# Access Compliance Report

## Public Rights-of-Way

### (Curb Ramps)

Intersection ID: 4496	Main Street: HIGH_GLEN_DR	Cross Street: NORCROFT_DR	Location: NE
ADA ID: 051076B2DB77	Ramp Type: Perp	Initial Pass/Fail: Fail	Overall Compliance: No
Codes/Mitigation Info/Possible Solution		Field Measurements/Component Compliance

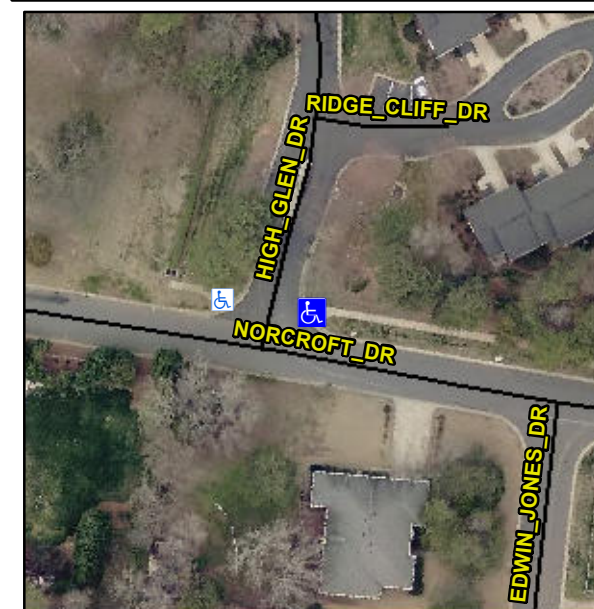
**Not Found, R304.5.1, R304.2.2, R304.5.3**

Compliance	Description	Data	Compliance	Description	Data
N/A	Ramp Length (in)	122.0	No	Ramp Slope (%)	11.6
No	Ramp Width (in)	41.0	No	Ramp XSlope (%)	7.5
N/A	Flare Type LT	N/A	N/A	Flare Type RT	N/A
N/A	Flare Slope LT (%)	N/A	N/A	Flare Slope RT (%)	N/A
N/A	Flare Traversable LT?	N/A	N/A	Flare Traversable RT?	N/A
N/A	Landing Length (in)	N/A	N/A	DWS Provided?	N/A
N/A	Landing Width (in)	N/A	N/A	DWS Contrast?	N/A
N/A	Landing Slope (%)	N/A	N/A	DWS Length (in)	N/A
N/A	Landing X Slope (%)	N/A	N/A	DWS Full Width?	N/A
N/A	Landing Curb? (Y/N)	N/A	N/A	DWS Offset (in)	N/A
N/A	Shared Landing?	N/A			
N/A	Gutter Ponding?	N/A	N/A	Gutter Slope (%)	N/A
N/A	Gutter Lip Ht (in)	N/A	N/A	Gutter X Slope (%)	N/A
N/A	Painted X Walk1?	No	N/A	Painted X Walk2?	N/A
	X Walk 1 Direction	To NW		X Walk 2 Direction	N/A
N/A	X Walk 1 Width (in)	N/A	N/A	X Walk 2 Width (in)	N/A
	X Walk 1 Slope (%)	1.7		X Walk 2 Slope (%)	N/A
	X Walk 1 X Slope (%)	6.2		X Walk 2 X Slope (%)	N/A

**Remove & Replace Entire Ramp.**
